Catherine McAuley Catholic College Modification 1

Modification to allow for short term interim traffic
arrangements to enable operation of the school.
State Significant Development Modification Assessment
(SSD 8989 MOD 1)

September 2020

Published by the NSW Department of Planning, Industry and Environment

Figure 3 | Temporary Access Plan (Source: Applicant's Modification Report)

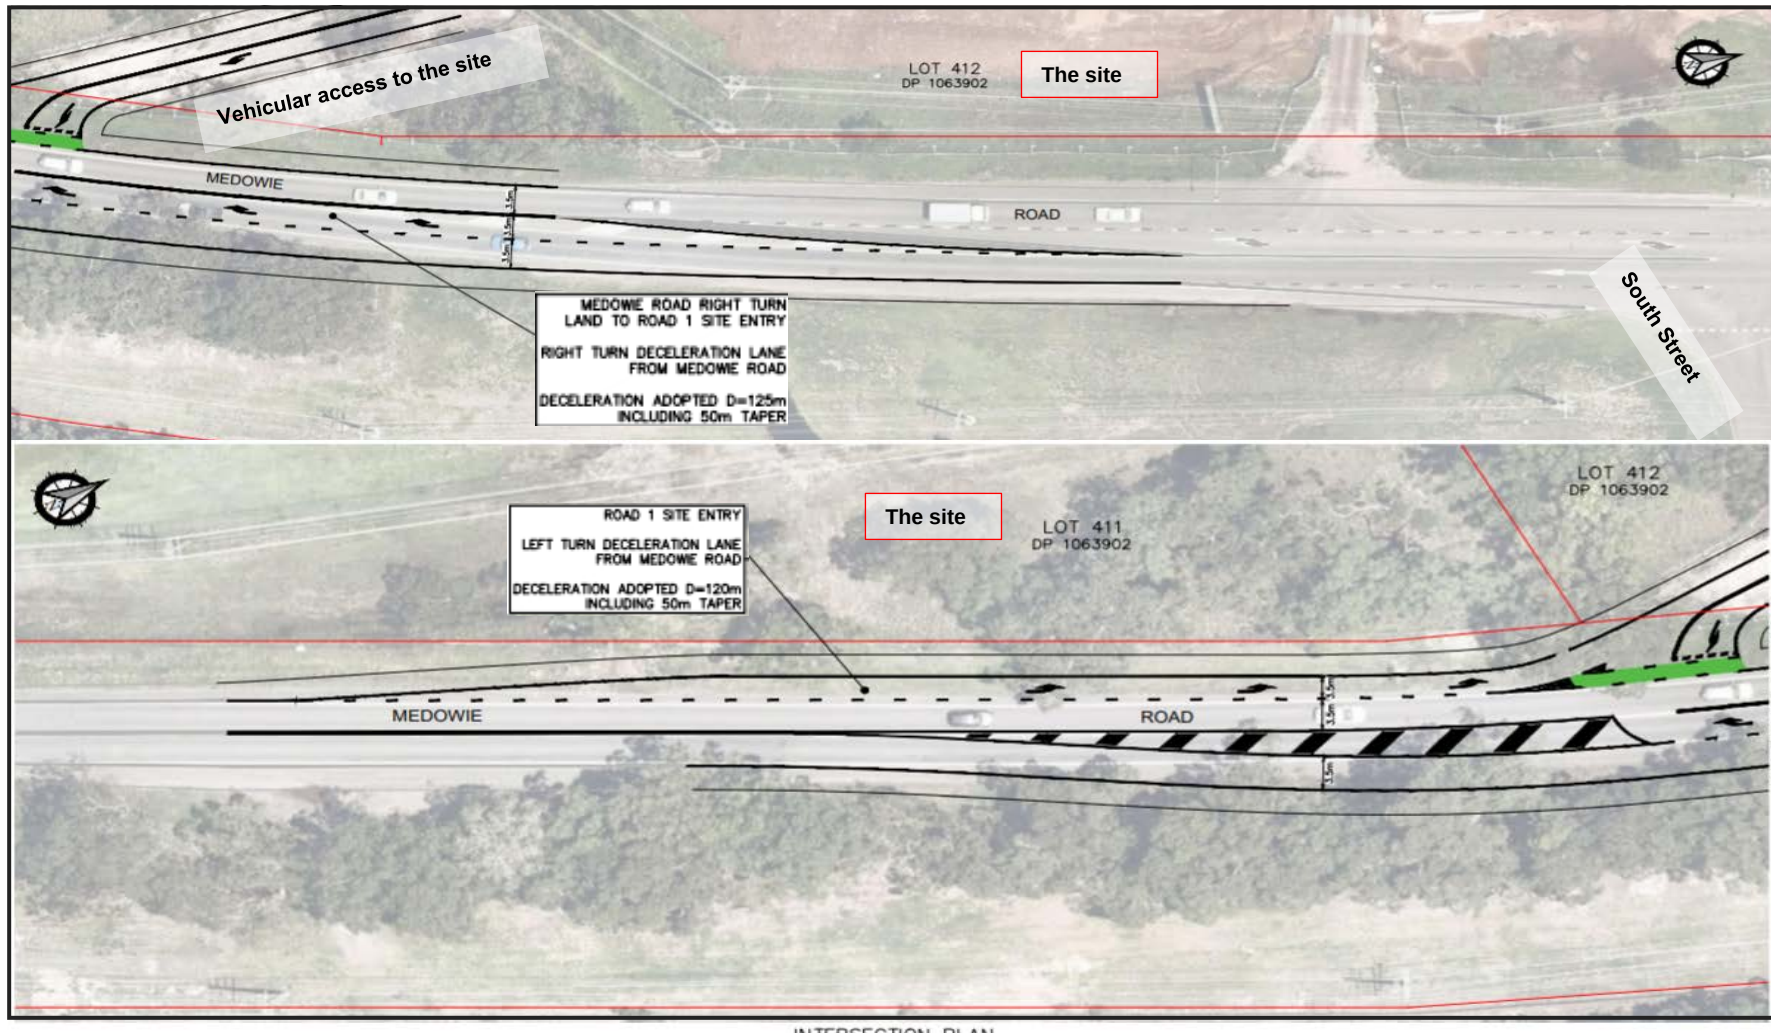
The proposed modification seeks to amend the requirements of condition E38 and allow commencement of operation of the school (Stages 1A, 1B and 2A and 2B only) prior to the completion of the proposed upgrades to the Medowie Rad/South Street intersection. To support the proposed amendment, the application provides details of interim intersection arrangements and alternative access to the site whilst the main signalised intersection works are being undertaken. The proposed interim works include:

- additional pavement and lane on Medowie Road to allow for a left turn deceleration lane directly into the site.
- creation of an additional lane for the purpose of decelerating on and turning right across Medowie Road into the site.
- dual in/out lanes for vehicular access at the southern corner of the site with direct connection to the internal road network and parking facilities.
- provision of new temporary line marking and traffic control measures to accommodate the changes to traffic flows in the interim.

The Applicant has advised that the short term interim access would be decommissioned once the main signalised intersection is complete.

Figure 4 | Temporary intersection design (Source: Applicant's Modification Report)

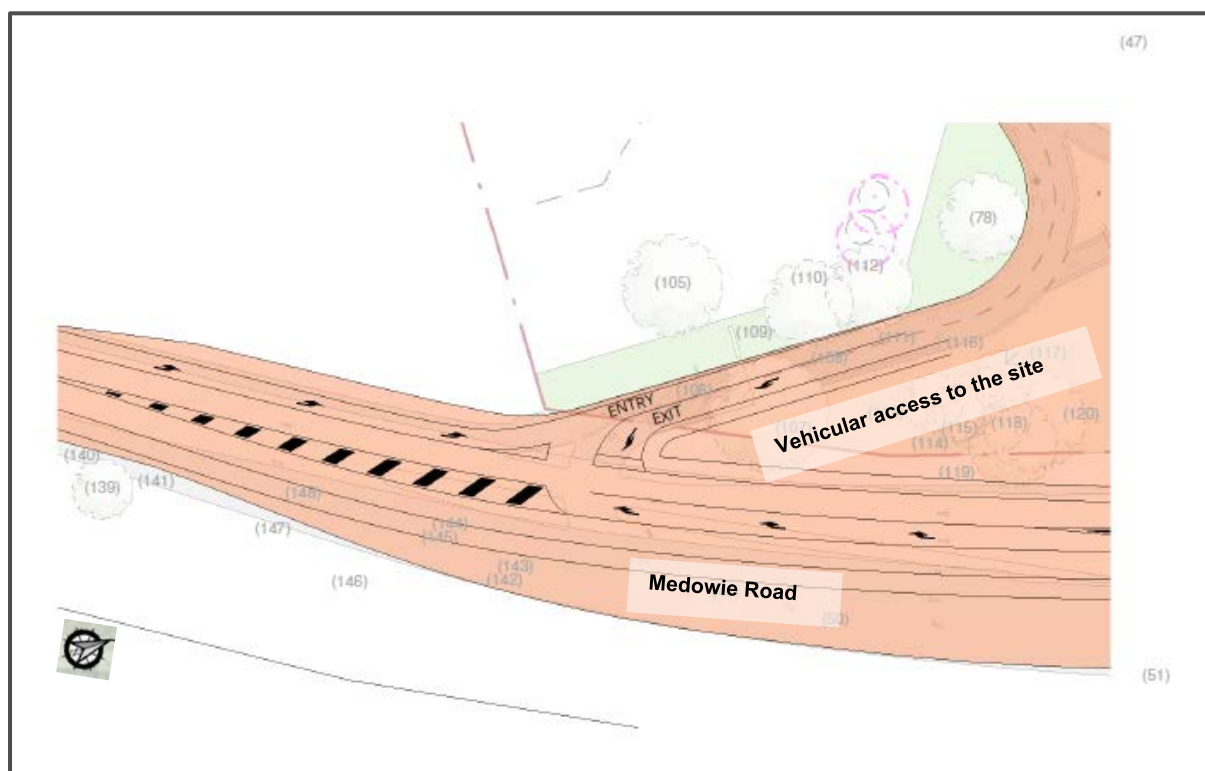
A temporary access driveway is proposed at the southern boundary of the site on Medowie Road. This driveway would allow both left and right turns into the site, with sheltered turn lanes (separate lanes) provided for both movements. Exit movements are proposed to be restricted to left out only. The location of the temporary is such that it would permit drivers to immediately turn right into South Street after driving out of the site on to Medowie Road. The Applicant suggests that the drivers can then complete a U-turn at the roundabout of South Street/Championship Drive and then turning left from South Street onto Medowie Road. The location of these roads in the context of the site are identified in **Figure 5**.

The Department has reviewed the proposed traffic generation and recognises that the interim traffic arrangement would have a level of adverse impact on the local road network. **Table 1** demonstrates that the intersection of the interim access driveway / Medowie Road would perform at LoS A for the drop-off / pick-up periods. Vehicles utilising the interim access would be able to turn around inside the site and therefore no queuing is expected at the intersection.

Considering the temporary nature of the impact on the Medowie Road / South Street intersection, the Department accepts the intersection performance and its impacts on the local road network. The Department is also satisfied that the temporary access to the school is acceptable.

However, the Department considers that this level of intersection performance on a regional road would not be acceptable in the longer term. Consequently, the Department has recommended a condition requiring the Applicant to ensure that the final intersection works commence prior to operation of Stage 1A and 1B and that it is completed within 9 months of commencement of operation otherwise additional school cohort cannot commence at the school.
